## Referees' Comments to the Authors

### Reviewer 1

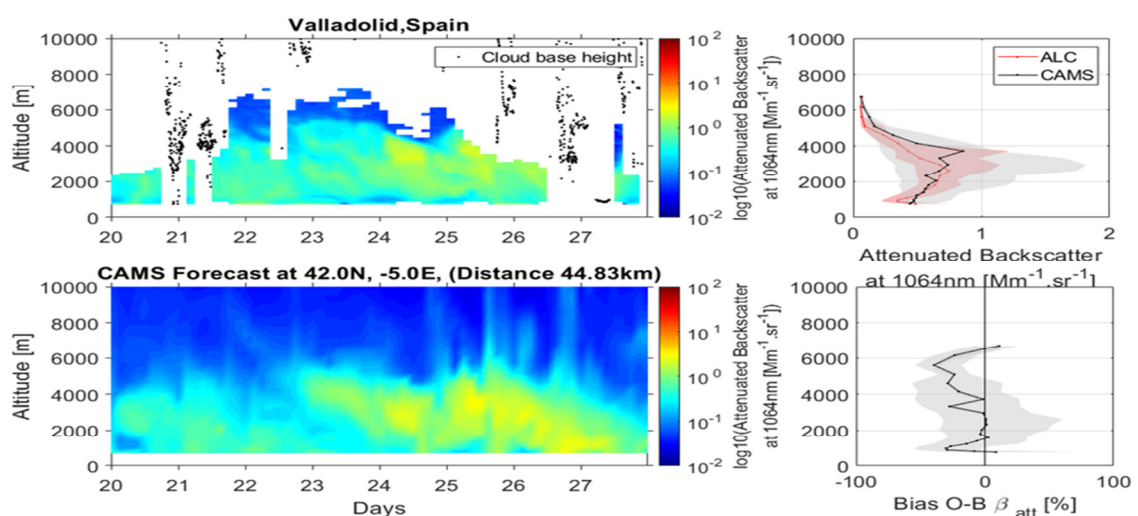
Introduction: l 62-67. This paragraph is farfetched. A ceilometer is measuring attenuated backscatter that is not proportional to Ice Water Content. If there is a link between these quantities, please add an equation and the references to support your conclusion. If not, I would suggest dropping this 10% requirement in the introduction and the section 5.2.

Section 5.2: l426. Keep the 10% only if the demonstration in the introduction is more robust.

New text (line 64) with references added for clarification: **for example, Illingworth et al, (2019) show that a calibration accuracy of 10% is needed when deriving 'O-B' statistics obtained by comparing the observed ceilometer backscatter ('O') from Saharan dust with the forward modelled backscatter ('B') from the ECMWF CAMS model.**

(line 69) **In most models the ice particle density is usually assumed to be inversely proportional to particles size (e.g. Brown and Francis, 1995) so IWC is proportional to extinction and for a given lidar ratio and small amounts of attenuation, the requirement is for a ceilometer calibration accurate to be 10%.**

The attached figure from Illingworth et al (2019) shows the O-B statistics for the ceilometer backscatter observed during a Saharan dust outbreak, and the forward modelled backscatter from the ECMWF CAMS model. The lower right hand panel shows that they agree to within 10% - this conclusion would not have been possible if the ceilometer were not calibrated to within 10%.
